Access Compliance Report Public Rights-of-Way (Curb Ramps)

Main Street: PLATAL_ST Cross Street: VAGAR_ST Location: NW

ADA ID: RPRK211119141652 Ramp Type: Type 4 - Parallel Initial Pass/Fail: Fail Overall Compliance: No Severity Score: 5

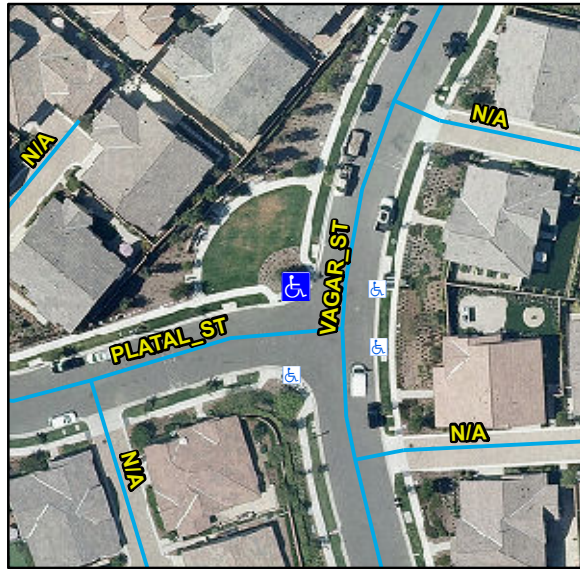
Compliance	Description	Data	Compliance	Description	Data
N/A	Ramp Length LT (in)	115	N/A	Ramp Length RT (in)	113
No	Ramp Width LT (in)	46	No	Ramp Width RT (in)	46
Yes	Ramp Run Slope LT (%)	6.3	Yes	Ramp Run Slope RT (%)	5.4
No	Ramp Cross Slope LT (%)	3.2	Yes	Ramp Cross Slope RT (%)	1.3
N/A	Landing Present	N/A	N/A	DWS Provided	N/A
N/A	Landing Length (in)	N/A	N/A	DWS Contrast	N/A
N/A	Landing Width (in)	N/A	N/A	DWS Length (in)	N/A
N/A	Landing Run Slope (%)	N/A	N/A	DWS Full Width	N/A
N/A	Landing Cross Slope (%)	N/A		DWS Offset Type	N/A
N/A	Landing Movement Obstructed?	N/A	N/A	DWS Offset Left (in)	N/A
	Landing Movement Type	N/A	N/A	DWS Offset Right (in)	N/A
N/A	Landing Shared	N/A			
N/A	Clear Space	Yes			
N/A	Clear Space To Crosswalk (in)	N/A			
N/A	Marked Crosswalk 1	No	N/A	Marked Crosswalk 2	No
	Crossing 1 Direction	S		Crossing 2 Direction	E
	Marked Crosswalk 1 Width (in)	N/A		Marked Crosswalk 2 Width (in)	N/A

N/A	Ramp Inside Crosswalk 1	N/A	N/A	Ramp Inside Crosswalk 2	N/A
	Crossing 1 Slope (%)	1.3		Crossing 2 Slope (%)	2.3
	Crossing 1 Cross Slope (%)	2.2		Crossing 2 Cross Slope (%)	0.9
N/A	Gutter Ponding	N/A	N/A	Curb Slope	7.9
Yes	Gutter Lip Height (in)	0		Road Run Slope (%)	0.7
N/A	Gutter Run Slope (%)	N/A		Road Cross Slope (%)	1.2
N/A	Gutter Cross Slope (%)	N/A	Yes	Perpendicular Joint Present	Yes
Yes	Overall Surface Condition	Acceptable			
	Cross Gutter Present?	No		Spandrel Present?	No
	Replace Cross Gutter?	N/A		Replace Spandrel?	N/A

Remove & Replace Curb Ramp With Two New Directional Ramps or Equivalent.

R304.5.1, R304.5.3, STD 1115
